14 CONSENT DECREE AND ORDER AS TO  
CAMPBELL UNION 76, HEDIA  
PETROLEUM INC. AND BOZORGHADAD  
TRUST ONLY

Union 76 – 3145 S. Bascom. – Campbell, CA

Disabled Access Evaluation: Inventory of Architectural Barriers

**DRAWING 01**

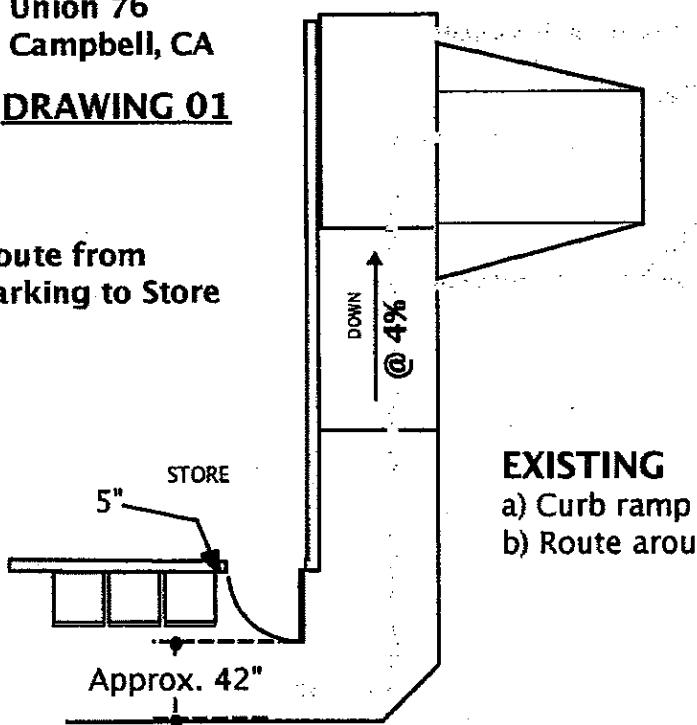
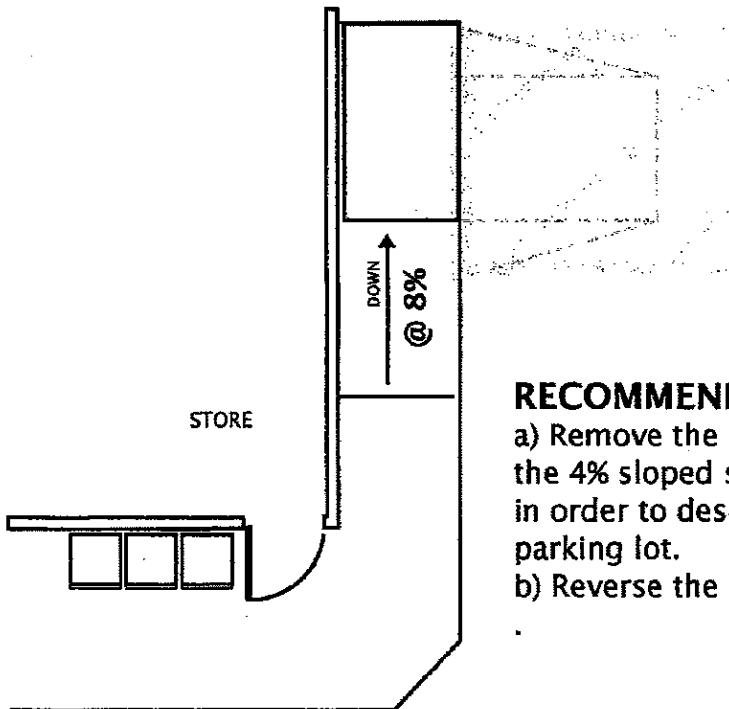
#	Barrier Description	Requirement	Code	Recommendation	Graphic
<b>ROUTES TO STORE AND RESTROOM</b>					
4	<b>Exterior Route to Store Entrance</b> The entry door, when held open by an internal mechanism, projects at a 90-degree angle from the building. That leaves <u>only</u> a 42-in. wide route between the door's leading edge and the outer edge of the raised walkway.	Persons with disabilities who travel from the parking area to the store must make a U-Turn around the leading edge of the open door. Both the CBC and ADAAG require that the route at this point must be minimum 48-in. wide because it is the first turn of a tight U-Turn. A tight U-Turn is one that turns around an object that is less than 48" wide. The door, which is approximately 2" wide is much less than 48-in.	4.3.3	Reverse the swing of the door so that it continues to swing out but would be hinged on the opposite side as where it presently is hinged.	Photo 03 DWG-01

5	<b>Entry Door - Exterior Side</b> Refrigerated beverage cases beside the entrance limit the clear width of the space next to the door's strike-edge to <u>only</u> 5-in.	Furthermore, CBC standards require that walkways be 48" wide. A door that encroaches into this required width while it is open in a fixed position is in conflict with this standard.	1133B.2.4.	No action is needed if the door is re-hung per the recommendation on Line 4, that is, the beverage cases may remain if the door is hinged from the opposite side.	Photo 04 DWG-01

- a) Curb ramp encroaches into access aisle
- b) Route around entry door is 42" wide

- a) Remove the curb ramp and rebuild the 4% sloped section of walkway more steeply in order to descend to the level of the parking lot.
- b) Reverse the swing of the entry door.

**DRAWING 03**

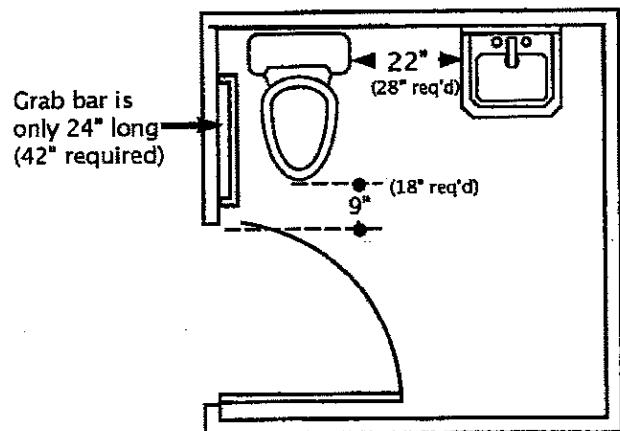
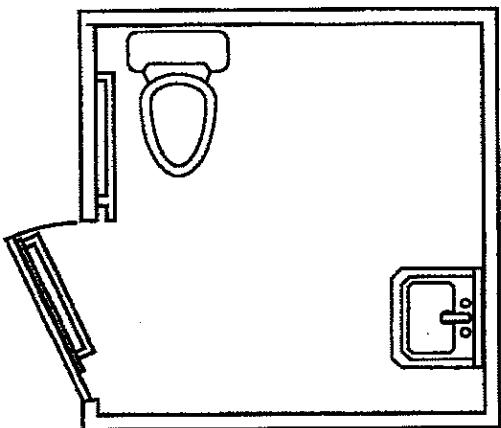
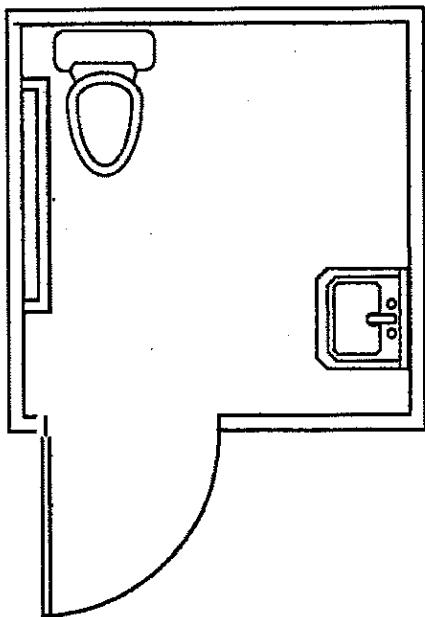
<b>RESTROOM</b>	The minimum clear width of an accessible route must be 36 in except at doors, especially when navigating a 90-degree turn	4.3.3 Fig. 7a and 7b	Move the refrigerated case that is in front of the restroom door and along the east wall, a minimum of 3-inches away from the restroom. Maintain minimum 36-inch routes to the restroom.	Photo 06 (7/4/04) DWG 02
8	<b>Door Hardware</b> Round doorknob is provided	Hardware must be operable with a single effort by lever-type hardware, panic bars, or other hardware that does not require tight grasping, pinching or twisting of the wrist.	4.13.9 1133B.2.5.2	Replace the round doorknob with lever-style hardware.	Photo 07
9	<b>Strike-Edge Clearance</b> The clear floor area of the door landing is limited by the proximity of the toilet. The door landing therefore extends only 9-1/2"	On the side toward which an interior door swings, 18" of clear space is required beyond the strike-edge (latch side) of the door	4.13.6 1133B.2.4.	Perform either A or B: A) Install a power door opener B) Relocate the door to the east wall (exterior wall) where	Photo 07 DWG 03

#	Barrier Description	Requirement	Code	Recommendation	Graphic
	beyond the edge of the door.			it would not have obstructions in the required door landing.	
10	<b>Side Transfer to Toilet</b> The clear space between the toilet and the lavatory is only 21-1/2" wide	A clear 28-in. wide space is required beside the toilet to facilitate safe transferring from a wheelchair to the fixture.	1115B.7.2	Relocate the lavatory to the northeast corner of the room.  Photo 08 DWG 03	
11	<b>Side Grab Bar at Toilet</b> The length of wall area next to the toilet where a grab bar can fit is limited by the door's location. The grab bar is therefore only 24" long and extends approximately 4" beyond the leading edge of the toilet fixture.	The grab bar adjacent to the toilet must be minimum 42-in. long and extend at least 24" beyond the leading edge of the toilet.	1115B.8 4.16.4	Perform either A or B:  A) Add a second grab bar onto the door if the door remains where it is and a Power opener is installed per recommendation A at line 9  B) Replace the 24" long grab bar with a 42" bar if the door is moved per recommendation B at line 9.  Photo 09

- Move lavatory to create side-transfer space
- Install power door opener to mitigate the lack of strike-edge clearance.
- Add grab to inside of door

- Move lavatory to create side-transfer space
- Relocate door to allow full-length grab bar and to provide required strike-edge clearance on the pull-side of the door.
